AMENDMENT OF SOLICITATION/MODIFICATION OF CONTRACT

2. AMENDMENT/MODIFICATION NO. 4	3. EFFECTIVE DATE 27-Apr-2004	4. REQUISITION/PURCHASE REQ. NO.	5. PROJECT NO. (If applicable)
6. ISSUED BY US Army Corps of Engineers, Kansas City District 760 Federal Building, 601 East 12th Street Kansas City, Missouri 64106-2896		7. ADMINISTERED BY (If other than item 6)

Barracks - 1st BDE, FY04, PN 36388, Fort Riley, Kansas
 The Solicitation is amended in accordance with the attached pages.

THIS AMENDMENT IS CONTAINED IN TWO (2) DOCUMENTS, PART 1 AND PART 2.

Sheet reference number:
B_E-201

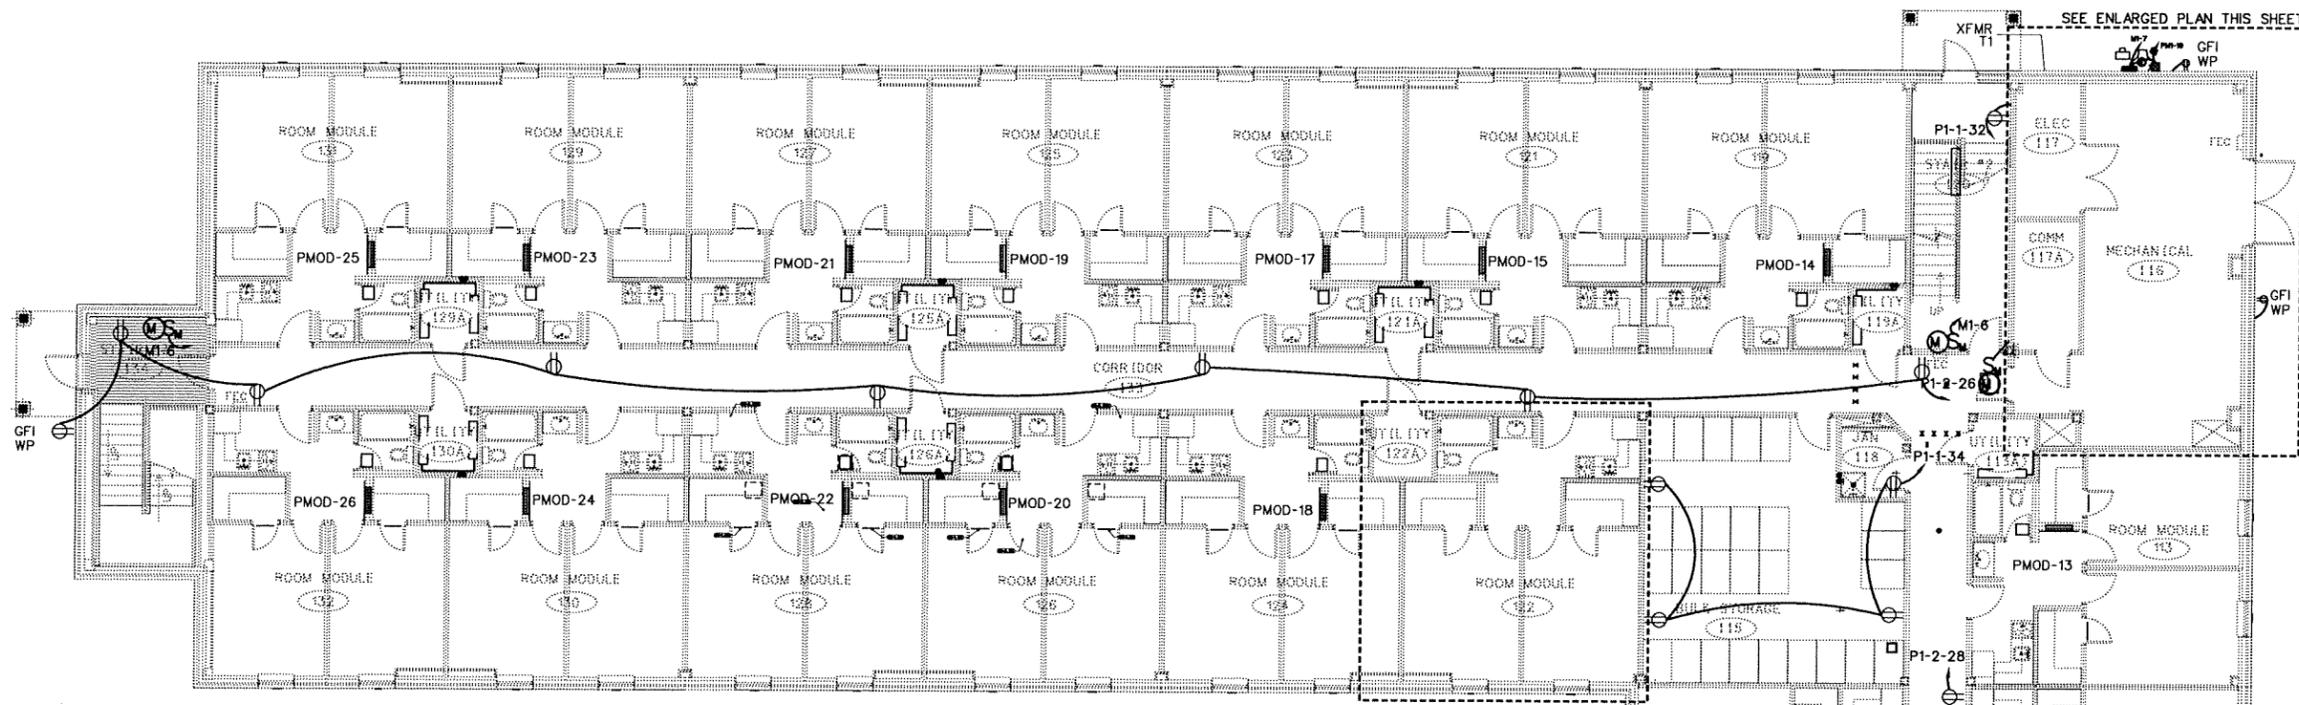
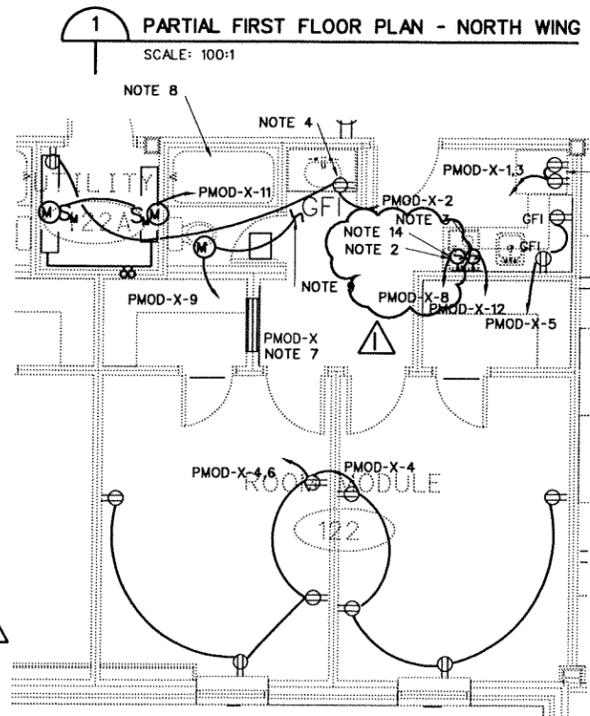
Rev.	Date	Description	Symbol	Date	Appr.
1	7/27/04	AMENDMENT 4 - COOKTOP STOVE TIMER SWITCH

- FLUSH MOUNT JB 154 MM ABOVE COUNTER TOP. CENTER JB WITH STOVE. INSTALL COOKTOP SWITCH. PROVIDE 16 MM CONDUIT FROM JB TO JB UNDER COUNTER TOP. CONDUIT AND JB TO BE UTILIZED BY TIMER SWITCH PROVIDED WITH COOKTOP ASSEMBLY. CONNECT COOKTOP CIRCUIT VIA SWITCH

Sheet reference number:
B_E-803

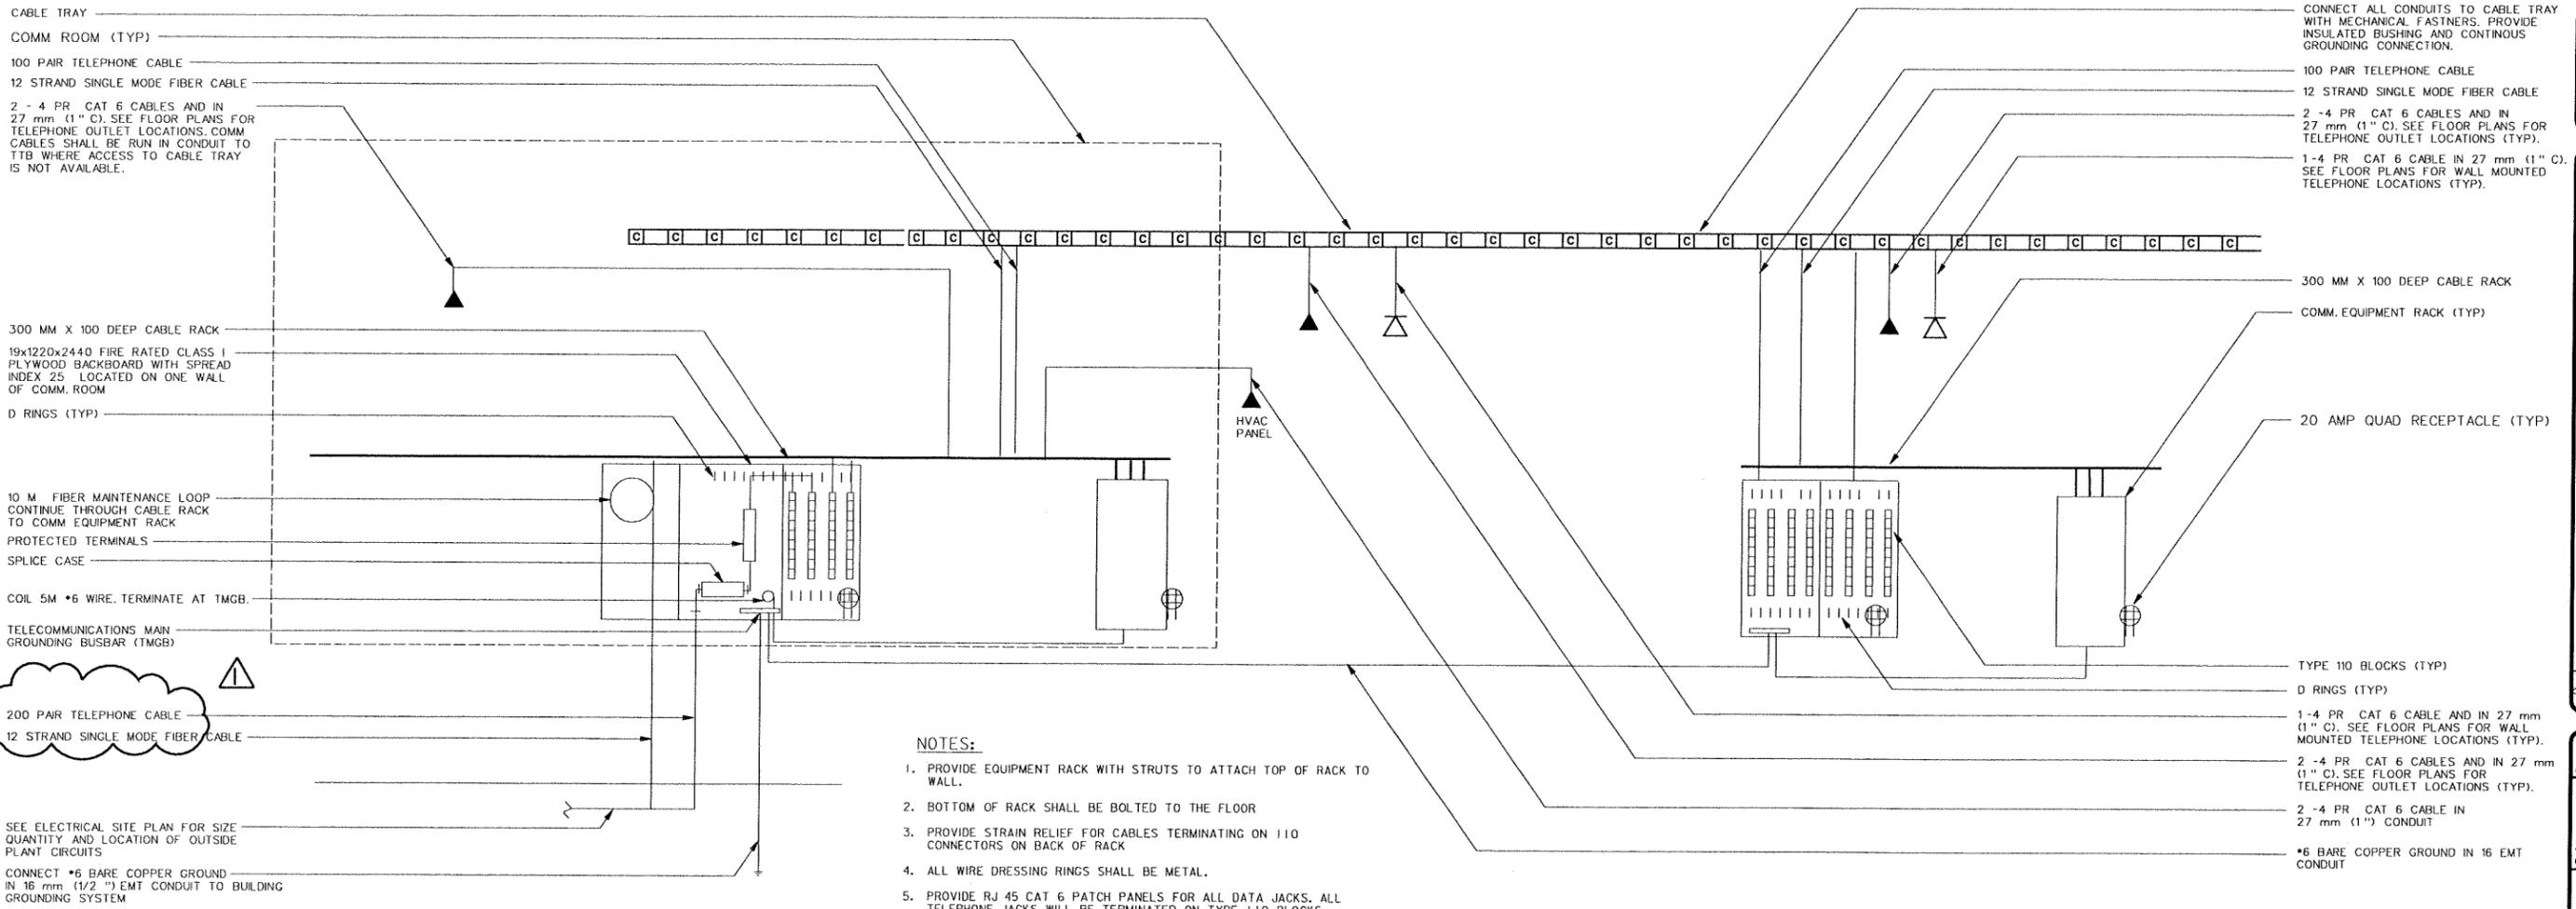
Rev.	Date	Description
1	11/27/04	CHANGE COOKTOP

FT. RILEY, KANSAS
 WHOLE BARRACKS RENEWAL FY04 PWS3388
 4 COF COMM ONE LINE DIAGRAMS

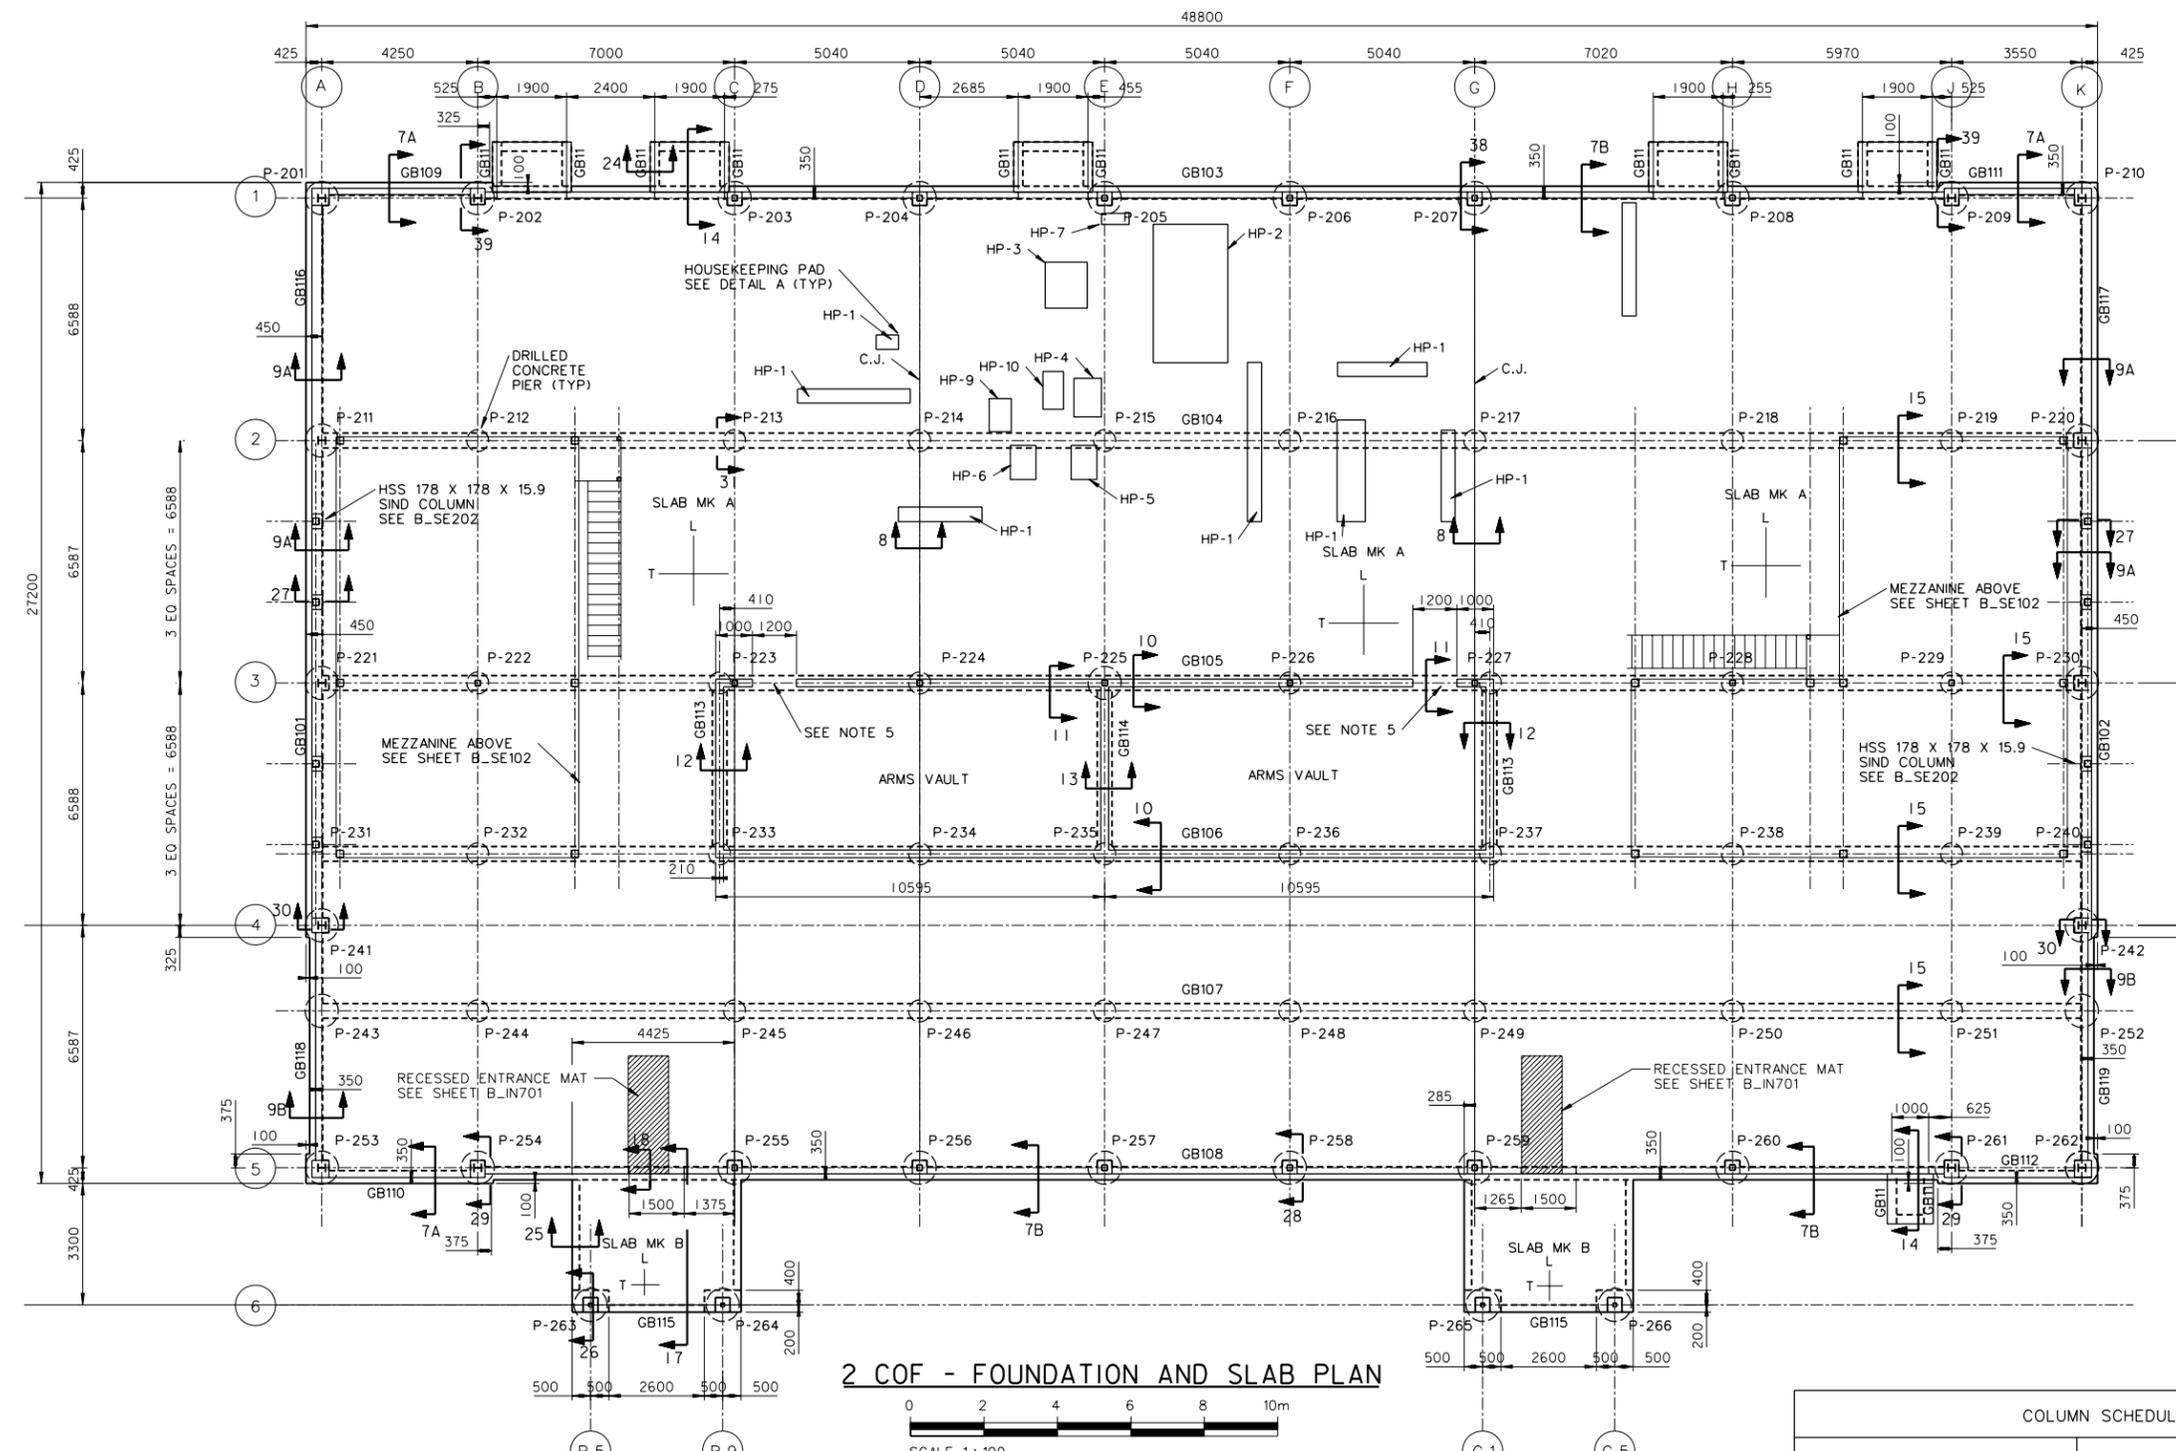
Rev.	Date	Description
1	1/27/04	AMENDMENT 4 - CORRECT TYPO
